Amendment Notice: Underground Raceway Infrastructure Layout

This bulletin introduces the following new GO Standard Specifications and Drawings:

- GO Design Requirements Manual (DRM), GO-DRM-STD-2017 Revision 3, dated February 2020

This Bulletin updates existing DRM (Feb. 2020) requirements for underground raceways and conduits and introduces new GO Standard Drawings illustrating electrical handholes, pull boxes and trench details as well as typical conduit routing on platforms. This revision better supports Metrolinx underground wire management for station electrical and communications systems.

REFERENCE DRAWINGS	ISSUE	REVISIONS	DRAWN BY: X.X.X. YY/MM/DD	DESIGNED BY: X.X.X. YY/MM/DD		XXXXXXXX STATION ----- SAMPLE SIDE PLATFORM - TYPICAL CONDUIT ROUTING
			CHECKED BY: X.X.X. YY/MM/DD	APPROVED BY: X.X.X. YY/MM/DD		
			SCALE: 1:XXX	FULL SIZE ONLY		
DWG NO.	TITLE	NO. DATE	ISSUED FOR	REV. DATE

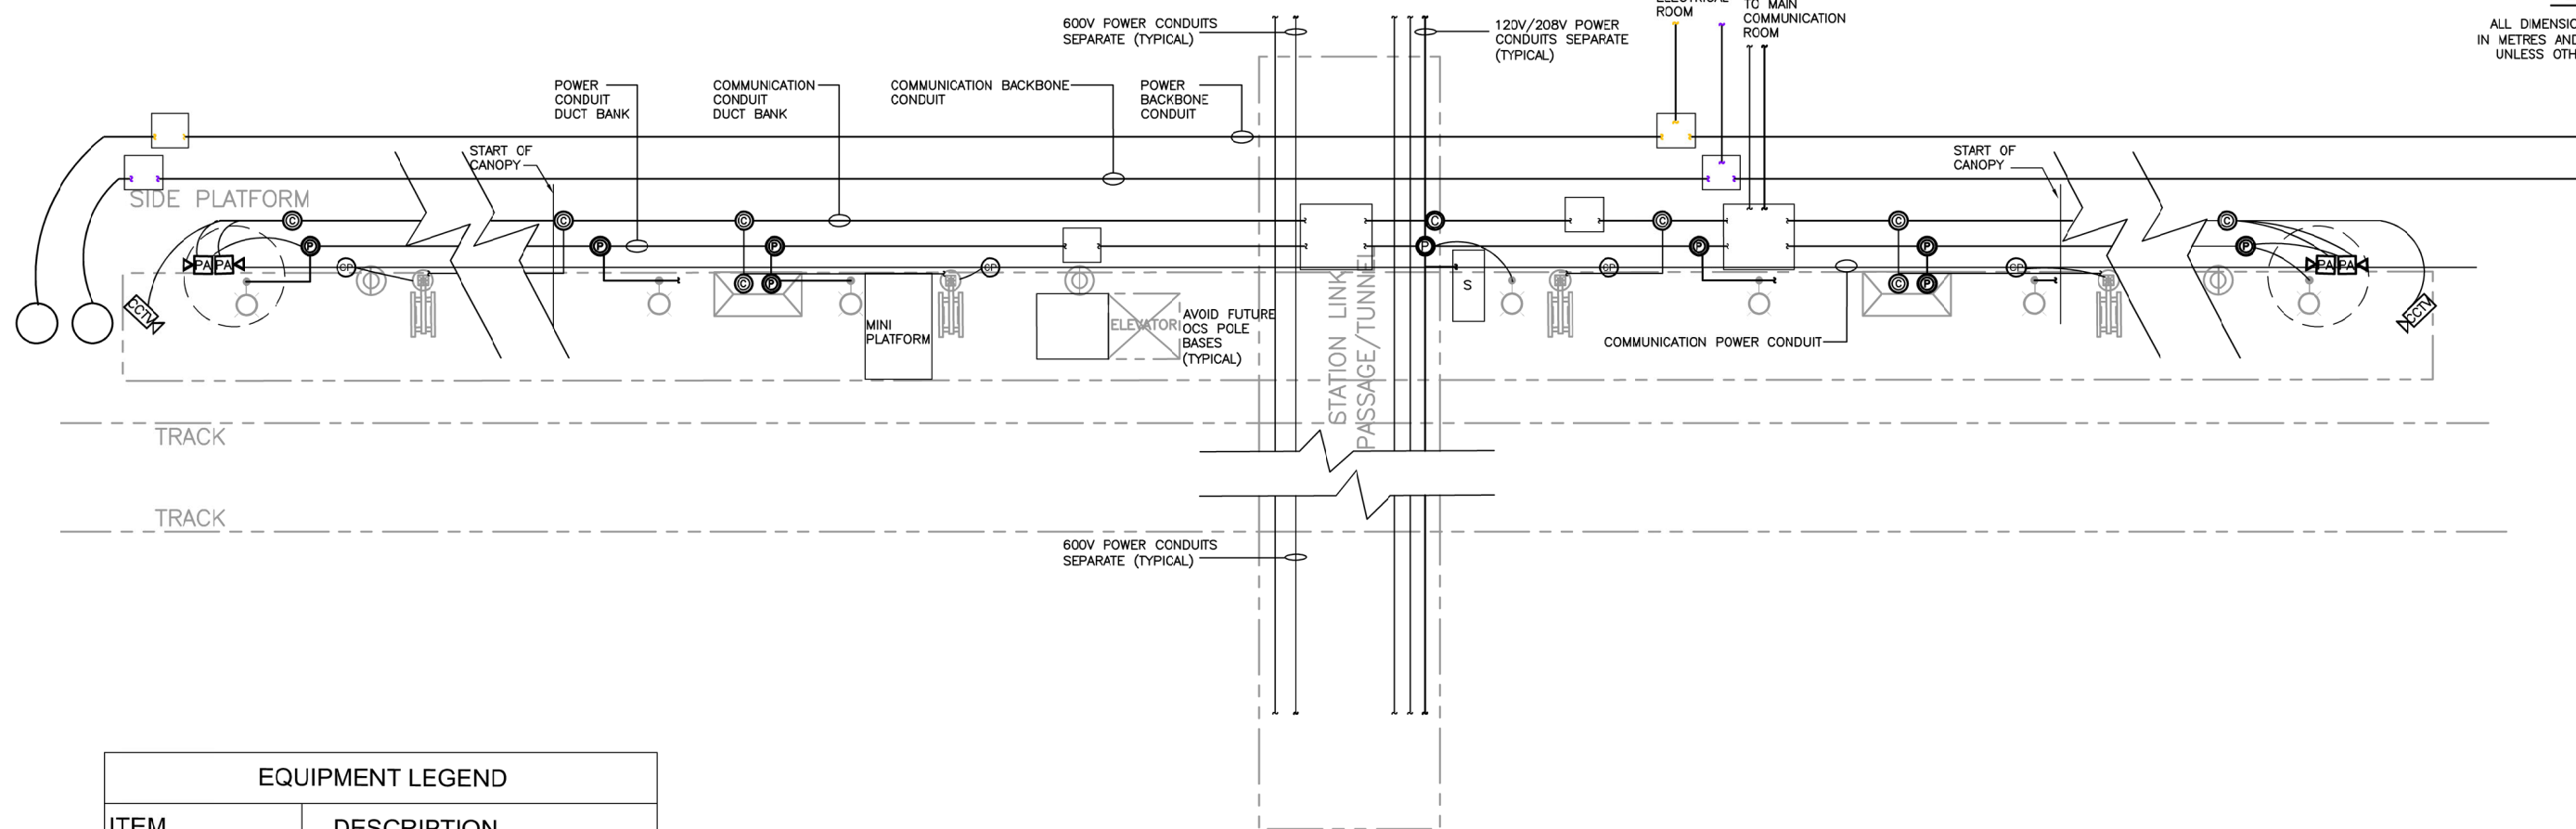
- WHERE LAND SPACE ALLOWS, ALL SIDE PLATFORM CONDUITS SHALL BE LOCATED OFF OF THE PLATFORM IN A PARALLEL CONDUIT RUN ON THE SIDE OF THE PLATFORM AWAY FROM THE TRACKS. FOR PLATFORMS WITH MINI-HUB ROOMS, THE MINI-HUB ROOMS SHALL BE FED DIRECTLY FROM THIS CONDUIT RUN AND THE MINI-HUB ROOM SHALL FEED ALL DEVICES.

- WHERE LAND SPACE ALLOWS, ALL MINI-HUB ROOMS SHALL BE LOCATED OFF OF THE PLATFORM. MINI-HUB ROOMS MUST BE LOCATED TO MAINTAIN A MAXIMUM 90m TO COMMUNICATION DEVICES ON THE PLATFORM.

- ALL STUB UPS AND ELECTRICAL EQUIPMENT SHALL ACCOMMODATE FOR FUTURE LEVEL BOARDING.
- POWER AND COMMUNICATION DEVICES IN CANOPY SHALL BE FED THROUGH MINI-HUB ROOMS OR SHELTERS. POWER AND COMMUNICATION HANDHOLES SHALL BE IN EVERY SHELTER OUT OF THE WALKING PATH AND NOT OBSTRUCTING THE DOORS.

- CCTV TO BE MOUNTED ON A SEPARATE DEDICATED POLE. EXCEPT FOR STRUCTURAL MOUNTED CAMERAS.
- POWER AND COMMUNICATIONS PULL BOXES SHALL NOT BE LOCATED DIRECTLY IN FRONT OF ELEVATORS.

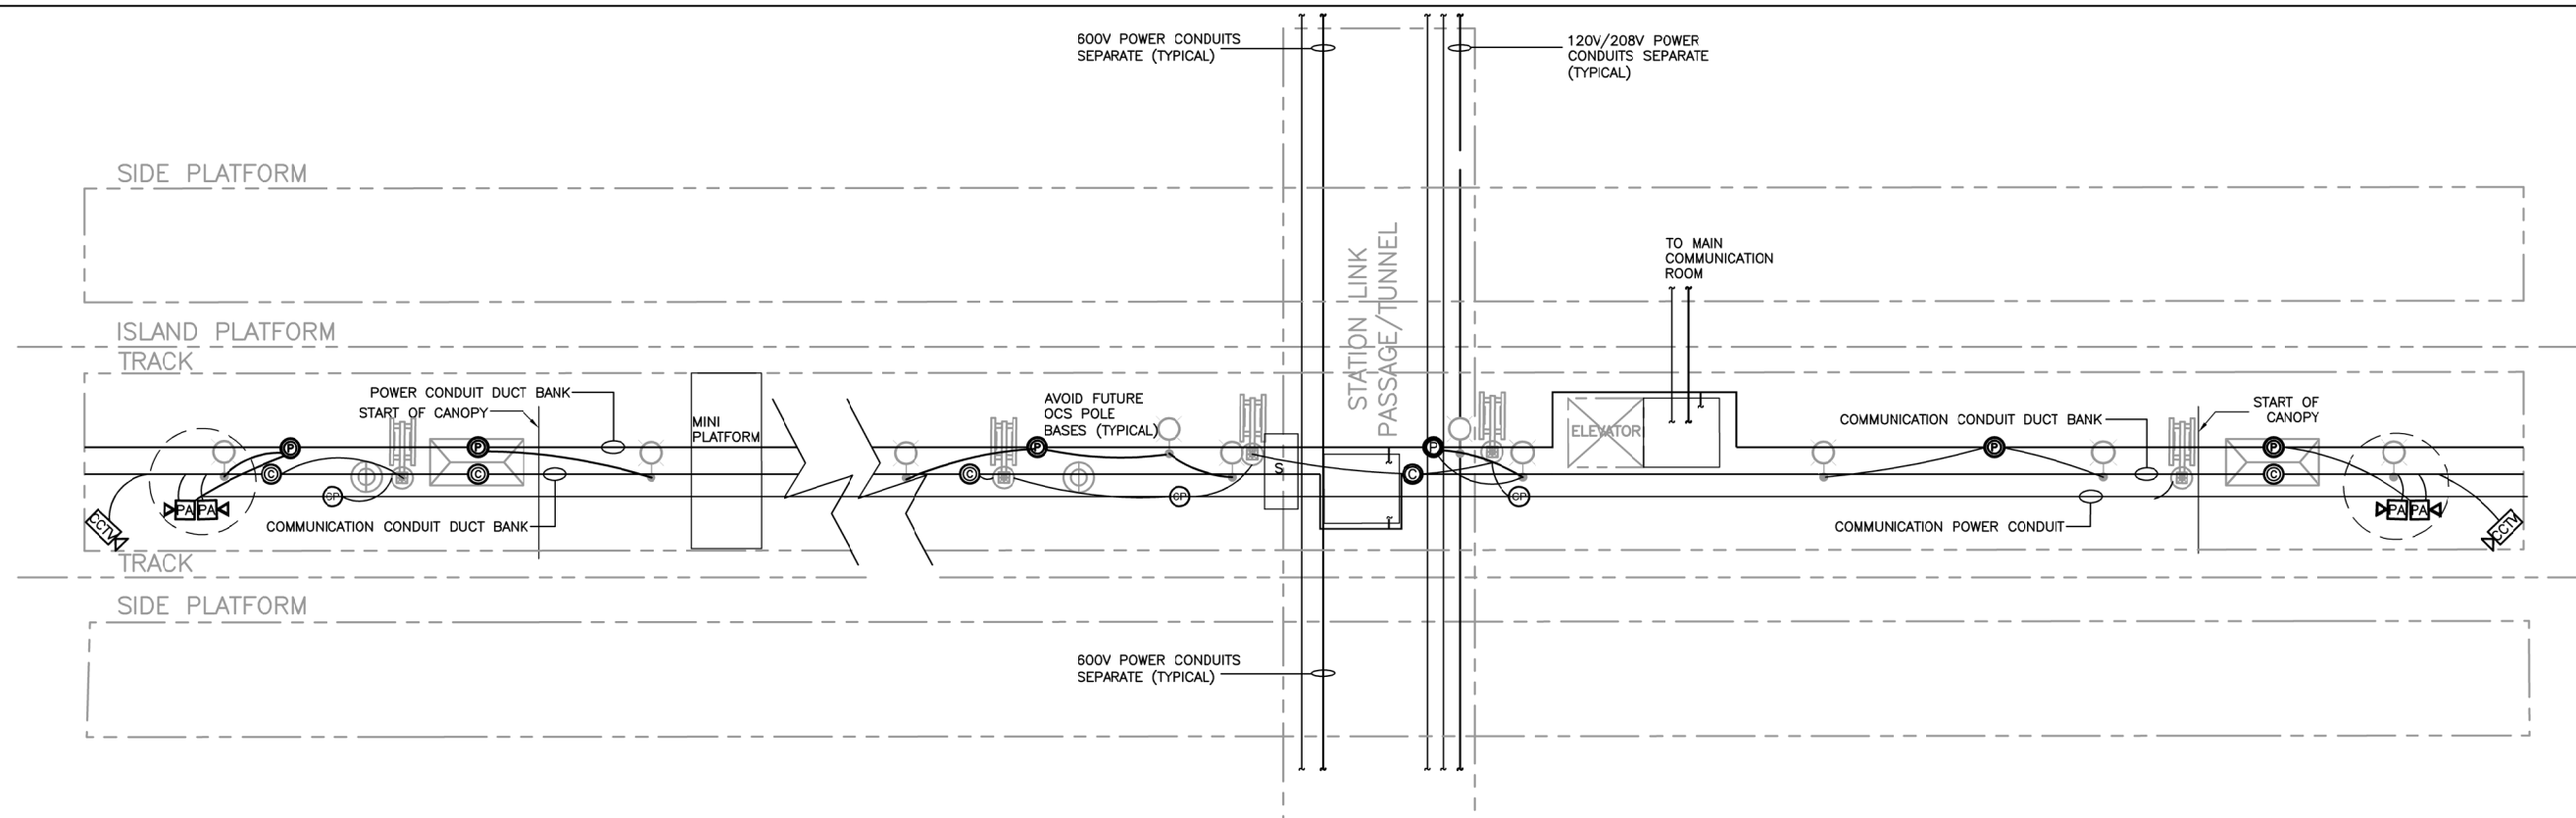
- WHERE LAND SPACE ALLOWS, ALL SIDE PLATFORM CONDUITS SHALL BE LOCATED OFF OF THE PLATFORM IN A PARALLEL CONDUIT RUN ON THE SIDE OF THE PLATFORM AWAY FROM THE TRACKS. FOR PLATFORMS WITH MINI-HUB ROOMS, THE MINI-HUB ROOMS SHALL BE FED DIRECTLY FROM THIS CONDUIT RUN AND THE MINI-HUB ROOM SHALL FEED ALL DEVICES.

- WHERE LAND SPACE ALLOWS, ALL MINI-HUB ROOMS SHALL BE LOCATED OFF OF THE PLATFORM. MINI-HUB ROOMS MUST BE LOCATED TO MAINTAIN A MAXIMUM 90m TO COMMUNICATION DEVICES ON THE PLATFORM.

- ALL STUB UPS AND ELECTRICAL EQUIPMENT SHALL ACCOMMODATE FOR FUTURE LEVEL BOARDING.
- POWER AND COMMUNICATION DEVICES IN CANOPY SHALL BE FED THROUGH MINI-HUB ROOMS OR SHELTERS. POWER AND COMMUNICATION HANDHOLES SHALL BE IN EVERY SHELTER OUT OF THE WALKING PATH AND NOT OBSTRUCTING THE DOORS.

- DESIGN MUST ACCOMMODATE (IF REQUIRED) A SEPARATE CORRIDOR BACKBONE FOR POWER AND COMMUNICATIONS.

SAMPLE ELECTRICAL TRENCH DETAILS - 1 OF 2

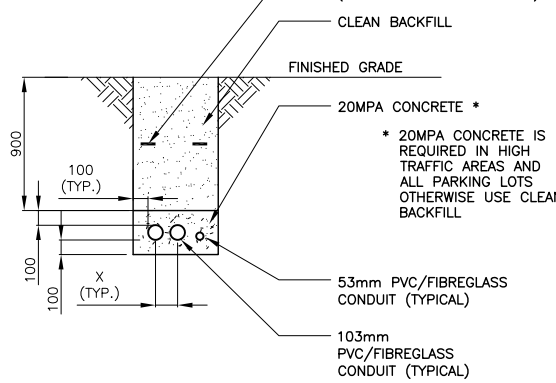
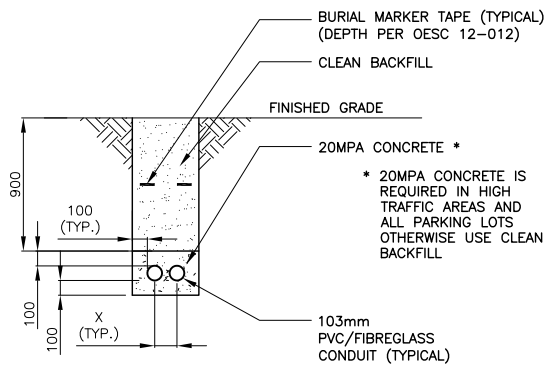
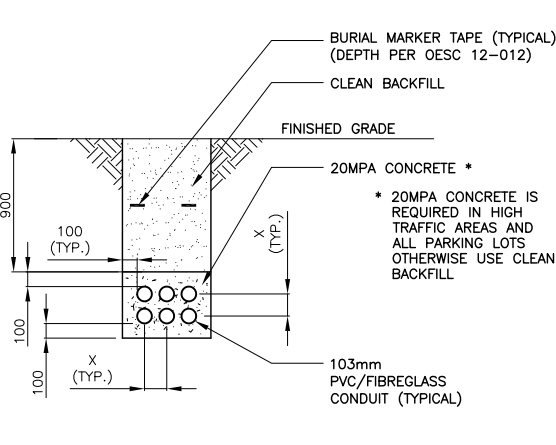
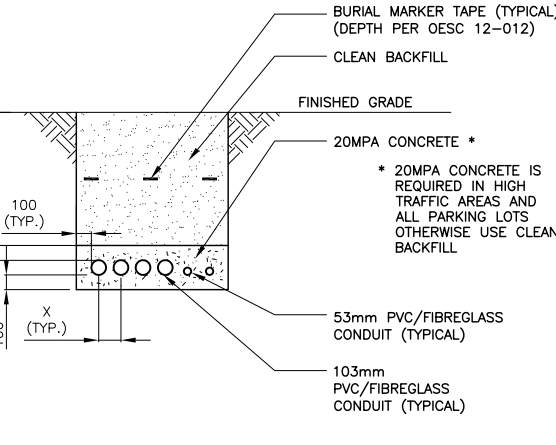
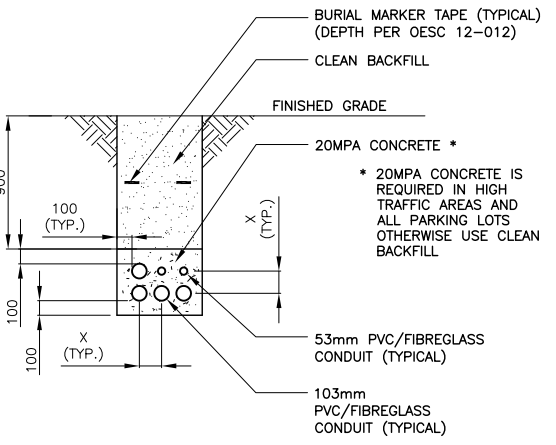
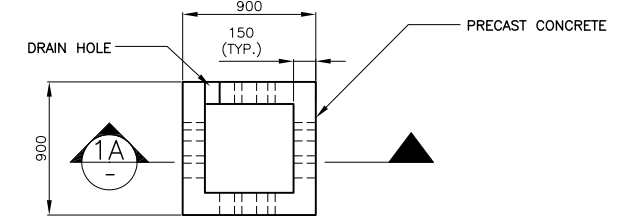
- POWER AND COMMUNICATION CONDUITS MUST BE IN SEPARATE DUCT BANKS.
- REFER TO METROLINX DRM FOR CONDUIT INSTALLATION, SPACING, CONDUIT FILL AND MAXIMUM NUMBER OF CONDUCTORS IN CONDUIT.

- DIMENSION "X" TO MEET OESC (ONTARIO ELECTRICAL SAFETY CODE) REQUIREMENTS BASED ON SYSTEM VOLTAGE.
- ALL ELECTRICAL SYSTEM GROUNDING FOR POWER AND COMMUNICATIONS SHALL BE INSTALLED INSIDE OF THE CONDUIT WITHIN THE OCLZ.

- CONDUITS CAN BE INSTALLED INSIDE SCHEDULE 40 OR GREATER STEEL PIPING (SLEEVES) TO CROSS TRACKS OR HIGH TRAFFIC AREA, PROVIDED THAT THE MINIMUM CONDUIT SPACING IS PER THE OESC, BASED ON THE SYSTEM'S VOLTAGE BEING MAINTAINED, AND THE METALLIC SLEEVE WITHIN THE OCLZ AREA IS BONDED TO THE TRACTION POWER RETURN.

- HANDWELLS AND MANHOLES MUST CONTAIN DRAINAGE TO PREVENT THE ACCUMULATION OF WATER. SLOPE DUCTS AWAY FROM BUILDING ENTRANCES.
- FOR HANDWELLS LOCATED IN ELECTRIFICATION ZONE, GROUNDING WIRE NEEDS TO BE VERIFIED TO WITHSTAND STEP AND TOUCH VOLTAGE LEVELS. COORDINATE WITH ELECTRIFICATION KA FALUT LEVELS AND TIMING. REFER TO DRM REQUIREMENTS OR GROUNDING - WHICHEVER IS MORE STRINGENT.

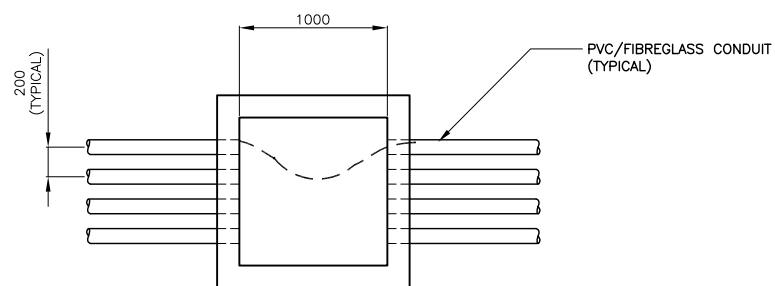
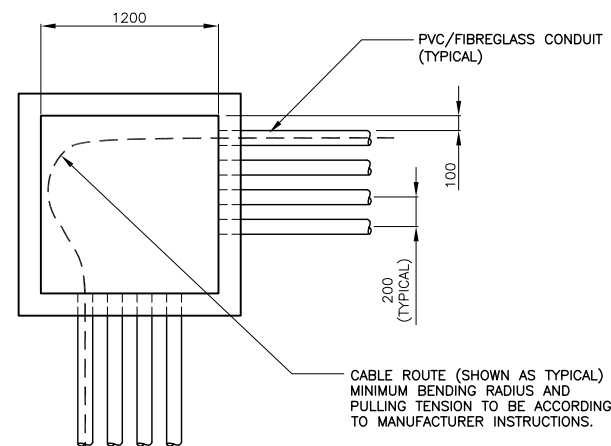
1. THE CALCULATIONS FOR THE SQUARE RECTANGULAR PULL BOX/MANHOLE ARE INTERNAL DIMENSIONS, WALL THICKNESS MUST BE ADDED.
2. WIDTH IS (2) – 90 DEGREE BEND PULL – 6X THE SIZE OF THE LARGEST CONDUIT PLUS 2X THE SIZE OF EACH ADDITIONAL CONDUIT IN THAT ROW, IF THERE ARE 4-100mm CONDUITS THEN THE SIZE IS 600+3X2X100 = 1200mm. ALSO THE CONDUITS ARE PLACED CLOSER TO THE OPPOSITE END OF THE PULL, TO ALLOW A LONGER RADIUS BEND OF THE CABLE IN THE PULL BOX/HANDWELL. AGAIN, IF THE MANUFACTURER ALLOWS 50mm SPACING BETWEEN THE CONDUITS THEN THE SIZE WILL BE 1200 – 150 = 1150mm.

3. CYLINDRICAL HANDWELLS UP TO 800mm DIAMETER SHALL BE USED FOR ONLY 2-53mm CONDUIT RUNS.
4. PULL BOX/MANHOLE COVER TO BE SECURED WITH BOLTS, GROUNDED IF METALLIC, AND IDENTIFIED AS PER METROLINX NAMING STANDARDS.

5. AS PER DRM AND SPECIFICATIONS, MANHOLE COLLAR IDENTIFICATION SHALL BE FOLLOWED.
6. PROVIDE SLACK PROVISION FOR ALL CABLES ENTERING A MANHOLE.
7. MANHOLES ARE TO BE DESIGNED WITH PROPER DRAINAGE.
